**Report to the Future Melbourne (Planning) Committee**

**Agenda item 6.2**

**Ministerial Referral No. TPM-2010-29/B  
54-56 and 58-64 A'Beckett Street, Melbourne**

**14 April 2015**

SOUTH ELEVATION  
 ABECKETT STREET  
 14050  
 A400

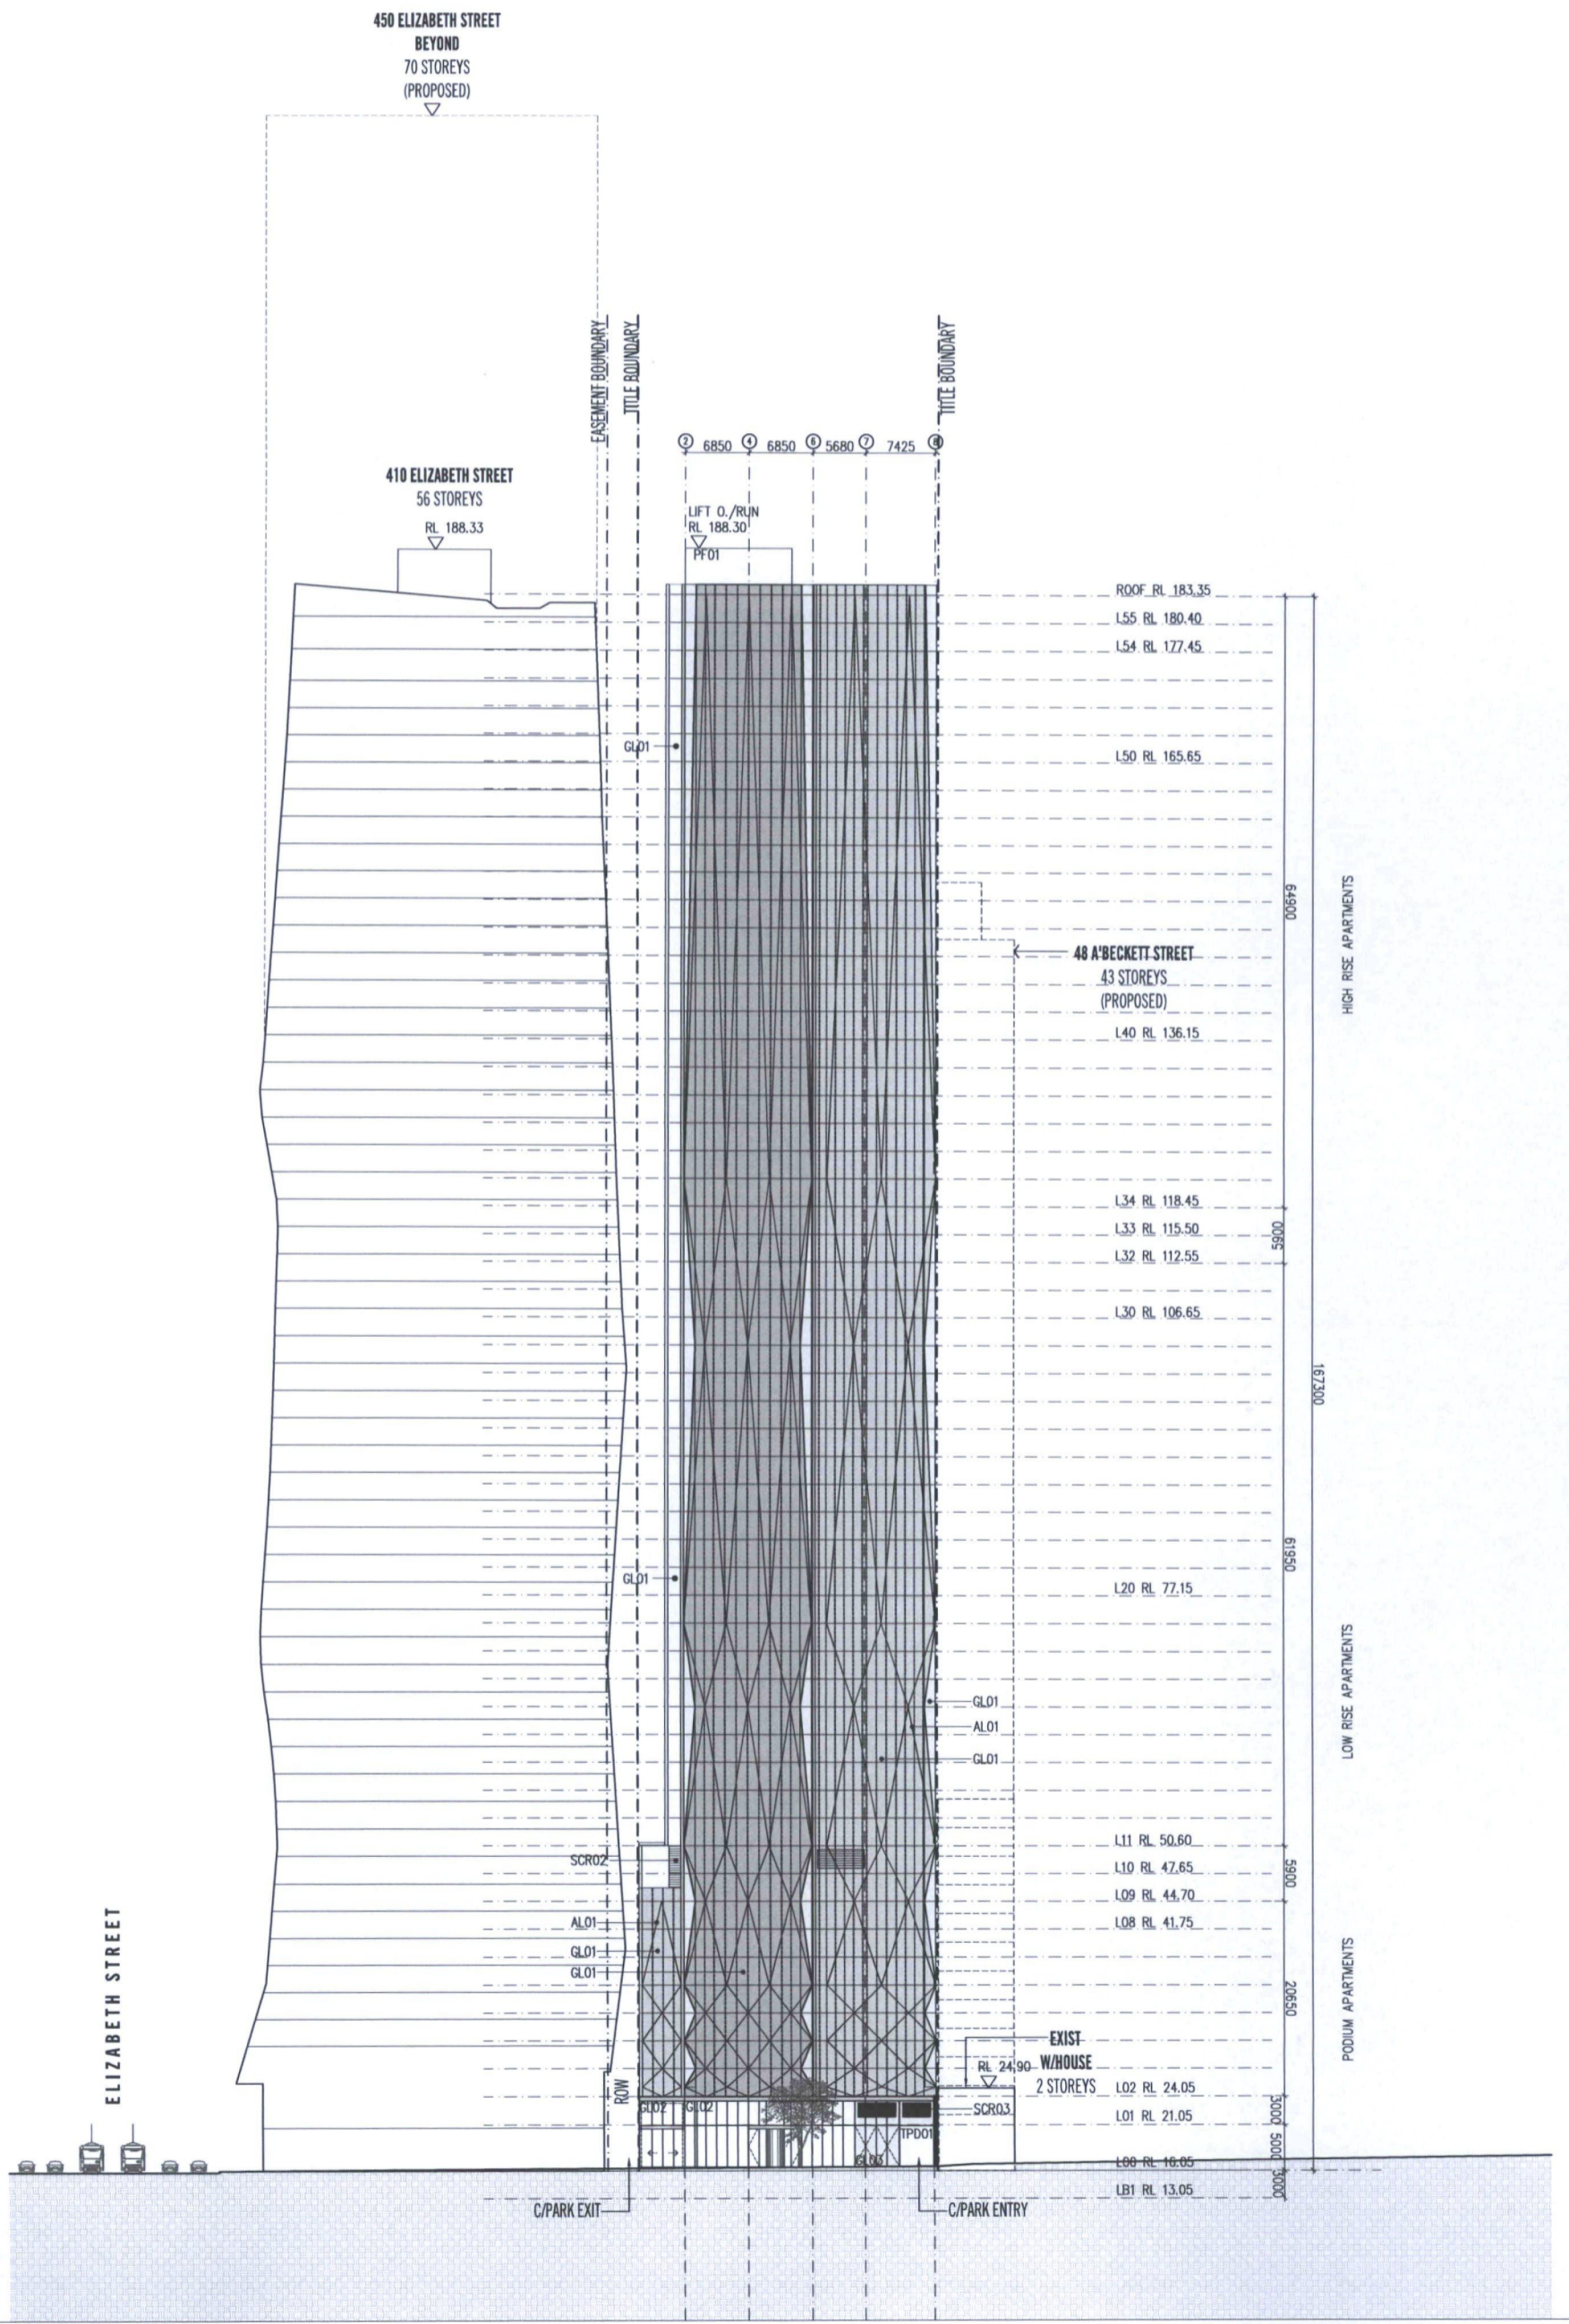
8. Concerns have been raised in relation to the lack of street setback for the additional 14.75m of building height proposed as part of this application. To satisfactorily address this matter, a minimum 5.4m building setback to A'Beckett Street at level 51 and above is to be required by recommended condition.

- a) A minimum 5.4m building setback to A'Beckett Street at level 51 and above, generally in accordance with the plans prepared by Elenberg Fraser, dated 2 March 2015.

Figure 2 – Building height comparison (approved vs. refused vs. proposed)

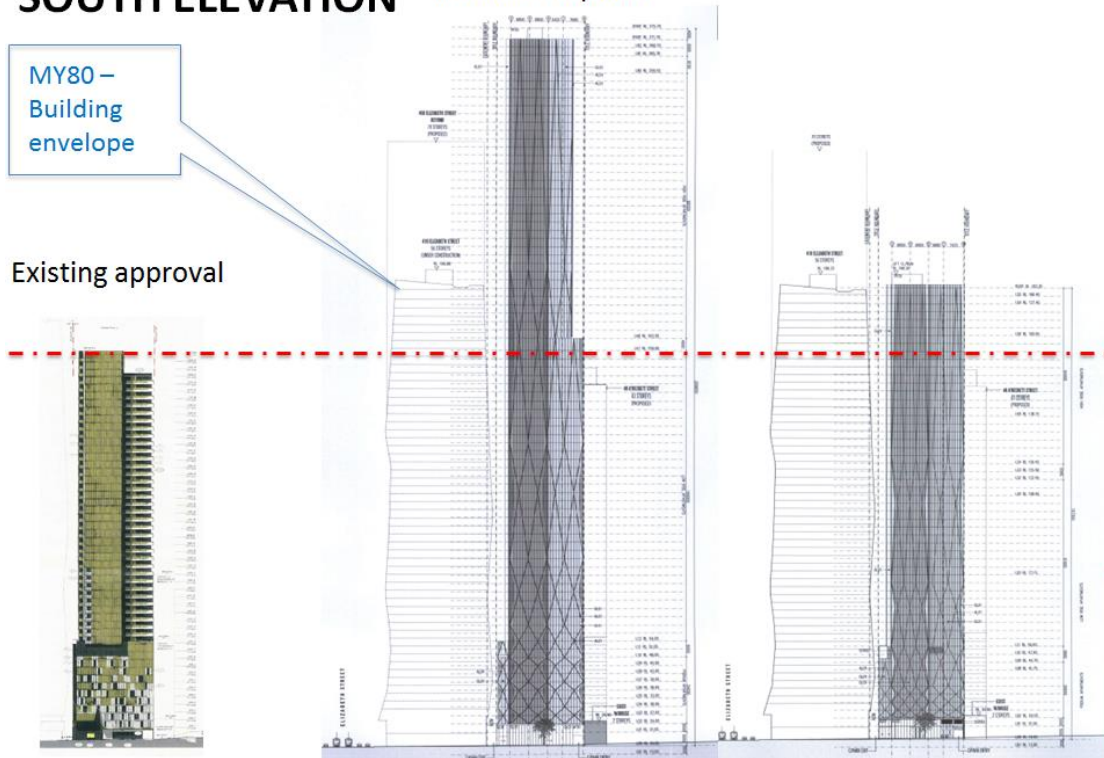
This is not considered to be the case for the amended proposal currently under consideration. This is further demonstrated by figures 2 and 3 below.

Figure 4 – Approved podium footprint L1-11 (left) vs. proposed podium footprint L1-9 (right)

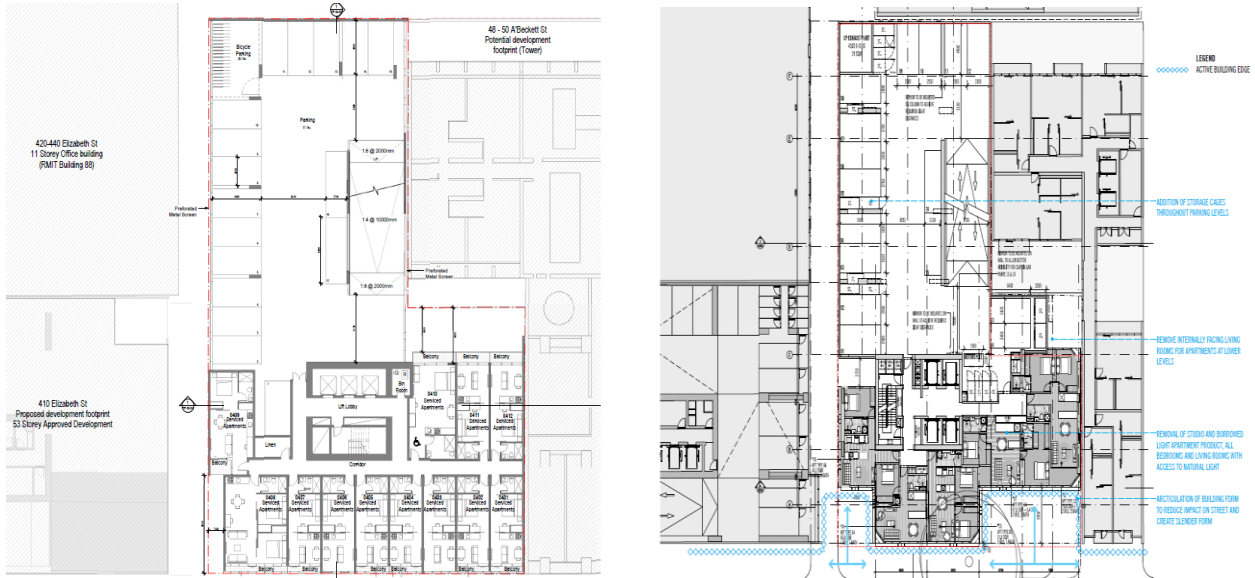
- A reduction in podium height from 11 to 9 storeys.
- A reduction in podium massing by way of a partial 5.4m recession of the building form to A'Beckett Street to form a building 'nose' to the street (see figure 4 below).

It is noted that the ground floor of the building is built out to the street to hold this edge.

Figure 5 – Approved (left) vs. proposed (right) tower footprint

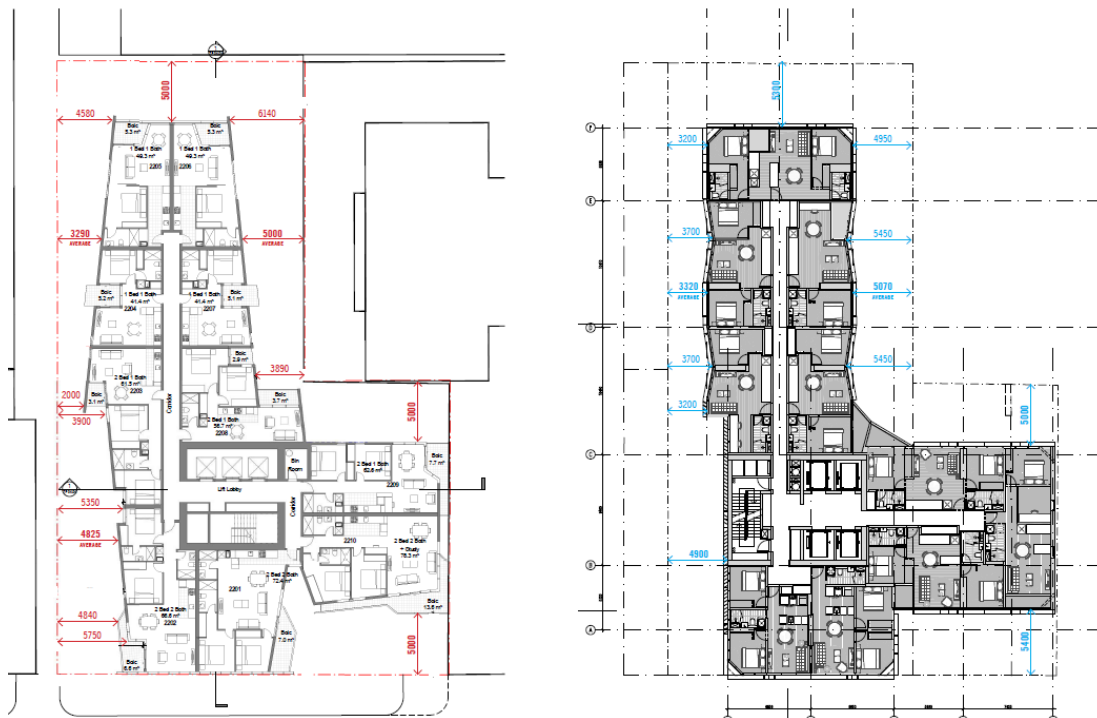
- The general increase of setbacks to property boundaries and reduction in tower footprint (see figure 5 below).
- A reduction in dwelling numbers from 502 to 463.
- A reduction in car park numbers from 194 to 80.
- Significantly improved layout and internal amenity for apartments.
- Provision of significant additional communal facilities for future residents. Increasing communal GFA from 35sqm for the approved development to 1,717sqm as part of this proposal, equating to approximately 3sqm per dwelling.

Given these changes it was agreed that, up to the current approved building height, the proposed changes will result in an improved outcome for future residents of the site and residents of adjoining buildings (including buildings permitted but yet to be constructed and under construction).
